Technical News

Ref. No.	Issuer company	Issue (yyyy/mm/dd)	Last modification (yyyy/mm/dd)
PV18NEX531	Digital Imaging Group	2018/09/14	
Subject			
Prevent lens front breakage			
Model (System model)	Destination	Serial number	Color
SEL2470GM	All	1800001 ~ 1883269

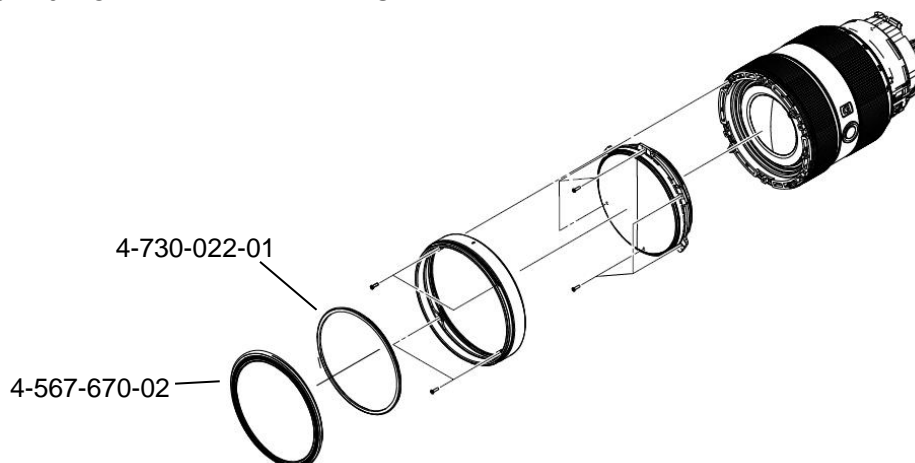
The front of the lens breaks due to drop

The structure was designed to transmit shocks easily

4-567-670-01

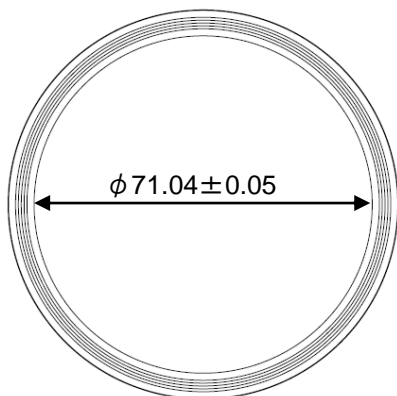
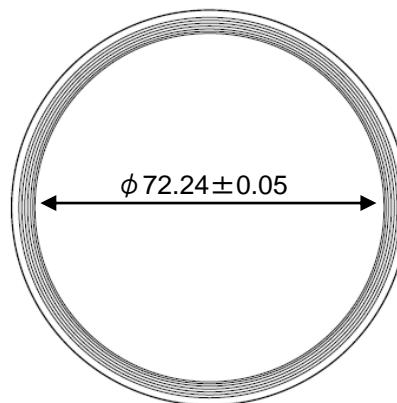
The following parts are changed and added.
 4-567-670-01 ⇒ 4-567-670-02: ORNAMENTAL PLATE
 4-730-022-01: ORNAMENTAL PLATE SHEET

*In case of the assembled ORNAMENTAL PLATE was 4-567-670-01:

1. Add ORNAMENTAL PLATE SHEET (4-730-022-01).
2. Exchange the ORNAMENTAL PLATE to 4-567-670-02
